Office Action Summary

10/593,483

HASEGAWA, MITSURU

DETAILED ACTION

Fig A
(annotated Fig 9 of Tanaka et al.)

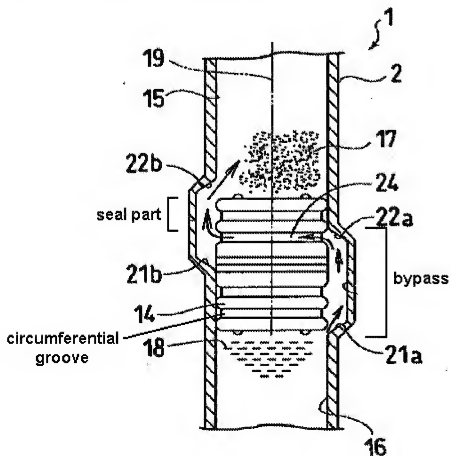
3. Re claim 1, Tanaka et al. disclose a pre-filled syringe 1 (Fig 1) which comprises a barrel 2 (Fig 1) having a tip 3 (Fig 1) in which a nozzle (the portion of member 6 to which the needle is attached, Para 41) is provided and an open base end 4 (Fig 1) and having an axis 19 (Fig 1) extending from said tip to said open base end, an intermediate gasket 14 (Fig 1,9) liquid-tightly partitioning an inside of the barrel into a front chamber 15 (Fig 1) and a rear chamber 16 (Fig 1) (Para 16,20), a plunger gasket 13 (Fig 1) located in a base end side of the intermediate gasket and sealing the inside of the barrel (Para 20), and a plunger rod 7 (Fig 1) connected to a base end of the plunger gasket (Para 20, Fig 1), and in which in a tip side of the barrel relative to the intermediate gasket there is formed a single bypass 20a (Fig 1,9) protruding outwardly in a radial direction (as seen in Fig 1,9), wherein the intermediate gasket includes a bypass communication passage 24 (Fig 9) providing communication between the front chamber and the rear chamber in cooperation with the bypass (Para 23), the bypass

communication passage consisting of a seal part (portion of gasket toward the tip side of passage 24, as seen in Fig 9 and Fig A below) contacting an inner wall of the barrel and liquid-tightly partitioning the front chamber and the rear chamber (Para 16,20,23), a circumferential groove (between ribs 14, as seen in Fig 9 and Fig A below) formed in an approximately circumferential direction of a base end side of the seal part; wherein an axial length of the intermediate gasket parallel to the axis of the barrel is longer than an axial length of the bypass parallel to the axis of the barrel (as seen in Fig 9), and when the axial length of the bypass is a_1 and an axial effective length of the seal part is b_1 , $a_1 > b_1$ (as seen in Fig 9 and Fig A below); and wherein a powdery medicine 17 (Fig 1,9) is accommodated in the front chamber and a liquid medicine 18 (Fig 1,9) is accommodated in the rear chamber (as seen in Fig 1,9). Tanaka et al. does not disclose a connection passage connecting the circumferential groove and the rear chamber, the connection passage being a spiral groove formed in an outer wall of the intermediate gasket. Higashikawa, however, teaches a gasket 104 (Fig 14) having a circumferential groove 105₁ (Fig 14) formed in an approximately circumferential direction of a base end side of a seal part 109₁ (Fig 14) and a connection passage 108 (Fig 14) connecting the circumferential groove and the rear chamber (Col 10, Lines 8-15), wherein the connection passage is a spiral groove formed in an outer wall of the intermediate gasket (as seen in Fig 14) for the purpose of communicating components housed in initially separated chambers with one another (Col 10, Lines 8-15). Therefore, it would have been obvious to one of ordinary skill in the art at the time the invention was made to modify Tanaka et al. to include a connection passage, as taught by

8. Applicant's arguments filed 9/10/2010 have been fully considered but they are not persuasive. Specifically Applicant argues that Tanaka et al. does not disclose "a single bypass" because it contains two bypasses. However, the phrase "...there is formed a single bypass protruding outwardly..." does not exclude multiple bypasses; rather it only requires that the device possess at least one bypass. It appears that the Applicant is attempting to recite that the device only has one bypass; however the language of "a single bypass" does not achieve this desire. Applicant also argues that the intermediate gasket of Tanaka et al. includes at least two seal parts with the bypass communication passage 24 provided between the seal parts. However, bypass communication passage 24 "consists" of the seal part (as noted in Fig A above) because the seal part forms a wall of the passage.
